Final Negative Declaration/Application Summary Report World Oil Tank Installation Project Port of Long Beach

State Clearinghouse # 2020100119

September 2021

APPLICATION SUMMARY REPORT

Damage to the Oil Storage Tanks due to Liquid Sloshing in the Past Earthquakes

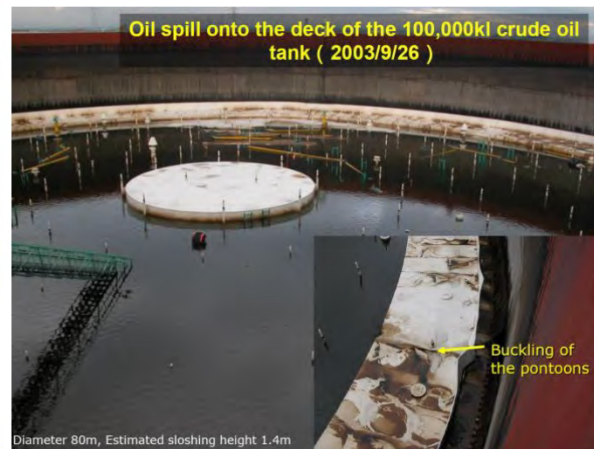
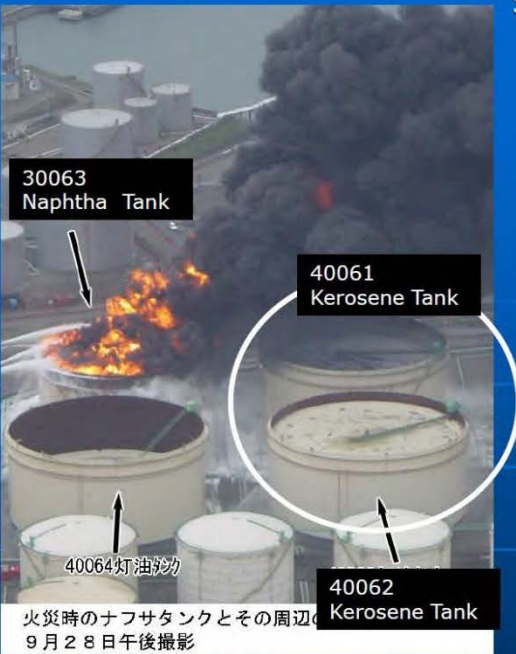
- Resonance between liquid (oil) and ground motion
- Larger diameter – longer sloshing period
- Higher liquid height – shorter sloshing period

Figure 3. Trends in California GHG Emissions. This figure shows changes in emissions by Scoping Plan sector between 2000 and 2018. Emissions are organized by the categories in the AB 32 Scoping Plan.

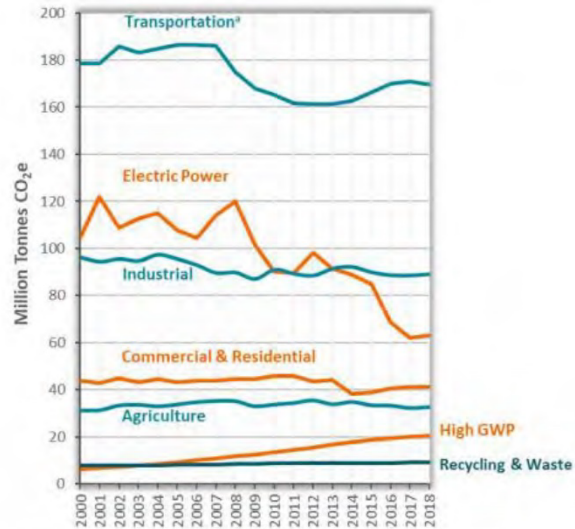
The largest industrial sector contributing to GHGs in California is Oil Refining, which is inherently connected with the use of the World Oil storage tanks.

The top GHG emitters in the AQMD Air Basin are almost entirely in the WCWLB area, and are dominated by oil refining and related facilities (which includes hydrogen production used in oil refining). Tesoro (now Marathon), which leases from World Oil, is notably the top emitter in the region (and also the top in the state). This sector (which includes the World Oil Project) heavily impacts regional and state GHG emissions; the Project needs cumulative impact analysis within this context.

Figure 1: PM and NOx Emission by Tier for a Backhoe⁹

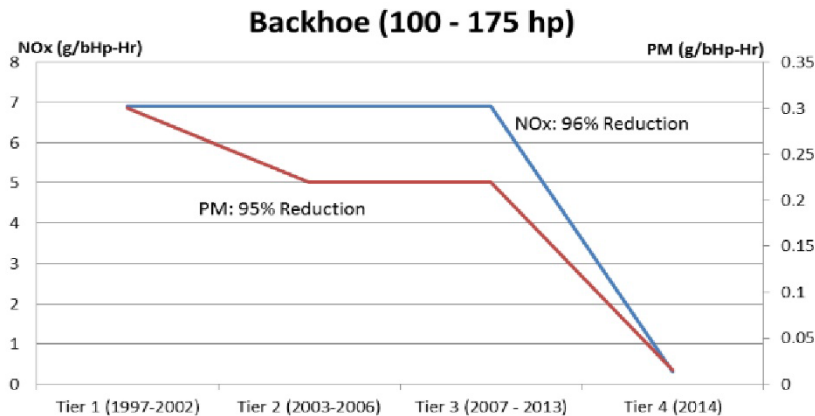
construction equipment for most equipment. However, the IS/ND does not impose mitigation specifically requiring the use of Tier 4 engines in all equipment. Therefore, the Applicant will be free to use equipment with lower tier engines, which are substantially cheaper and have higher emissions, thus significantly increasing construction emissions and construction health impacts. Comment 2.1. The IS/ND does not specify the engine tier or require the use of construction equipment with the engine tiers assumed in the air quality analysis as summarized in Exhibit 2.

The amount of pollution from construction equipment is categorized using a system of “engine tiers.” The higher the tier, the lower the emissions.⁶ For example, for a typical backhoe, four of which will be used to construct the Project,⁷ the emissions of NOx and PM in grams per brake horsepower hour (g/bHp-Hr) as a function of engine tier are shown in Figure 1.⁸

This figure shows that NOx exhaust emissions would be about 35 (7/0.2) times higher if all Tier 1 construction equipment were used instead of Tier 4 equipment. Similarly, this figure shows that PM exhaust emissions would be about 15 (0.3/0.02)

Figure 2: Distribution of Measured VOC Emissions in Relation to Emission Factor Estimates (lb/hr)⁴⁵

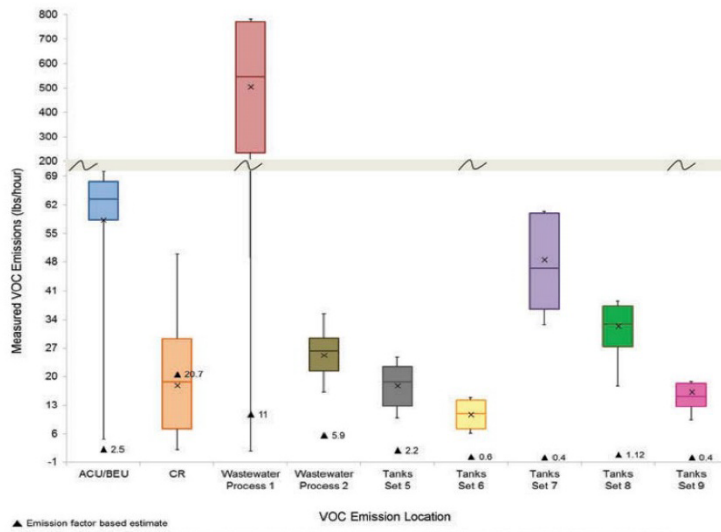
distribution of measured VOCs compared to emission factor estimates is summarized in Figure 2. Tank sets 5, 6, and 9 are external floating roofs, tank set 7 is two internal floating roof tanks, tank set 8 is four fixed roof tanks, and tank set 9 is two external floating roof tanks.⁴³ The highest relative error (>97%) occurred at the tank set 2 area, the tank set 3 area, and tank sets 1, 2, and 3, which are all internal floating roof tanks, proposed for the Project.⁴⁴

Figure 3: Comparison of Total VOC Emissions from a Range of Petrochemical Storage Tanks by IR-DIAL compared to AP-42⁴⁹

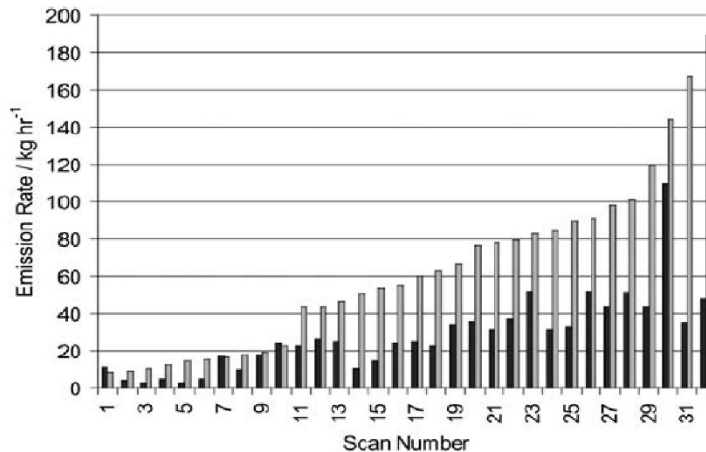
Sixth, IR-DIAL measurements at a UK refinery had consistently higher VOC emissions than estimated using the EPA Tanks program. This is illustrated in Figure 3.

Figure 4: Ratios of Emissions Measured with SOF and Mobile DOAS to Annual Average Emissions Reported to Texas⁵⁴

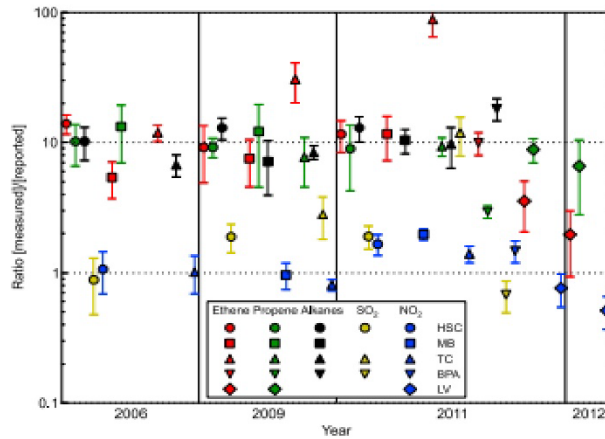
Eighth, in another study, Johansson et al. (2014) reported for refineries in Texas that, “Despite some significant variations from year to year and from area to area, there is a clear pattern of measured VOC emissions (alkanes, ethane, and propene) exceeding reported emissions with almost an order of magnitude on average, while no similar pattern exists for SO₂ and NO₂.”⁵³ This pattern is highlighted in Figure 4, where the ratios between measured emissions and reported annual average emissions are plotted for each year, species, and area.

Figure 5: Comparison of Measured and Calculated VOC Emissions from Refinery Storage Tanks⁶²

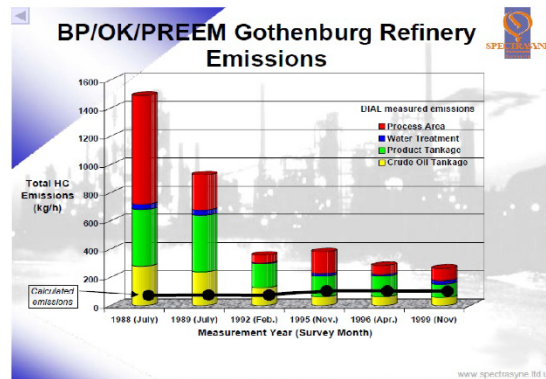
Figure 5, for example, compares DIAL measurements with calculated emissions at one refinery in Sweden. The underestimates are generally due to failure to address tank degradation over time; exclusion of upsets, malfunction, startups and shutdowns;

exclusion of some types of emission events; improper input parameters such as built-in defaults and winds that deviate from the average.⁶¹ Winds that deviate from average, such as the Santa Ana winds, are a concern in the area where the Project's tanks will be located.

Figure 6: Traditional Internal Floating Roof Tank⁷⁹

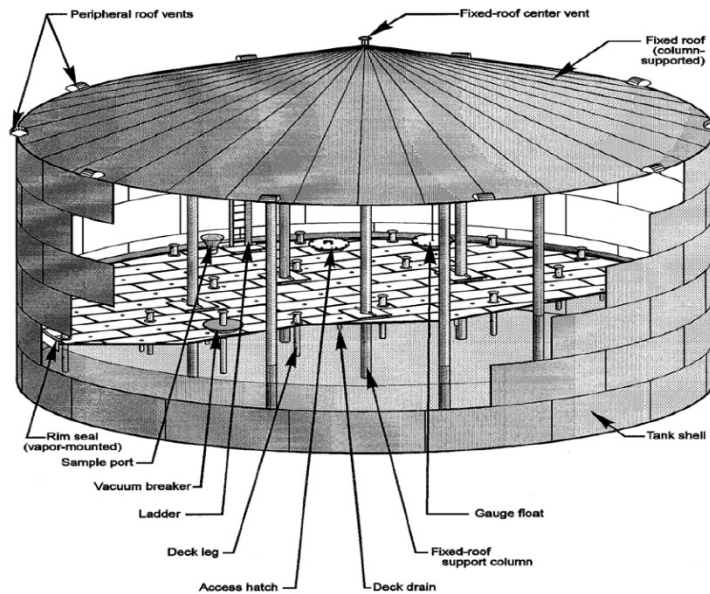
The Project involves two new internal floating roof storage tanks. These tanks do not have a self-supporting roof. Rather, the roof floats on the surface of the liquid inside the tank, reducing evaporative losses during normal operations. However, when the tank is emptied, the roof sits on deck legs at the bottom of the tank and is uncontrolled. Figure 6 shows a diagram of a traditional internal floating roof tank and the location of the deck legs.

Figure 7: Number of Days Air Quality in Zip Code 90802 Exceeded Ozone Ambient Air Quality Standards¹³⁴

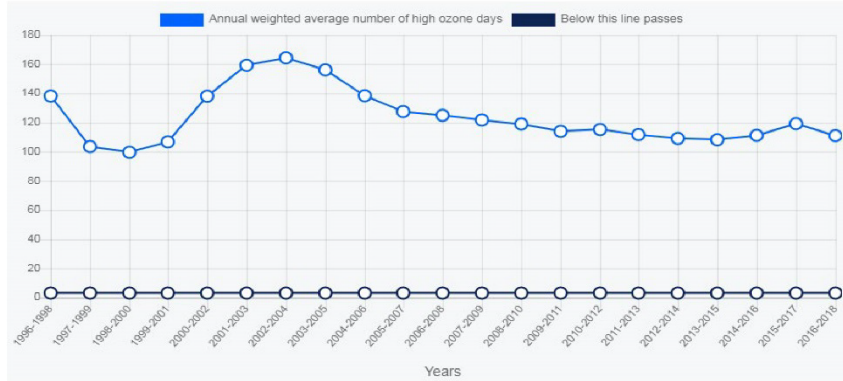
The South Coast Air Basin where the Project is located is in extreme nonattainment with the federal 1-hour and 8-hour ozone standards and in nonattainment with the state 1-hour and 8-hour ozone standards.¹³² In fact, the area where the Project is located has the worst ozone pollution in the entire United States.¹³³ The number of days that ozone standards were exceeded in the Project's zip code are summarized in Figure 7. The significant VOC emissions from the Project will aggravate existing violations of ambient air quality standards, resulting in significant public health impacts.

The Los Angeles–Long Beach area (zip code 90802), where the Project is located, has remained at the top of the worst ozone pollution list for 20 out of the 21 years that the American Lung Association (ALA) has been ranking pollution in its annual State of the Air Report.¹³⁵ Four groups of people are especially vulnerable to the effects of breathing ozone: (1) children and teens; (2) anyone 65 and older; (3) people with existing lung diseases, such as asthma and chronic obstructive pulmonary disease (also known as COPD, which includes emphysema and chronic bronchitis); and (4) people who work or exercise outdoors.¹³⁶ In the Project area (Los Angeles–Long Beach) in 2020, these included 10 million people with preexisting conditions that were at risk from ozone pollution, plus 15 million otherwise sensitive individuals (people of color and those living in poverty) who likely live and/or work outdoors:
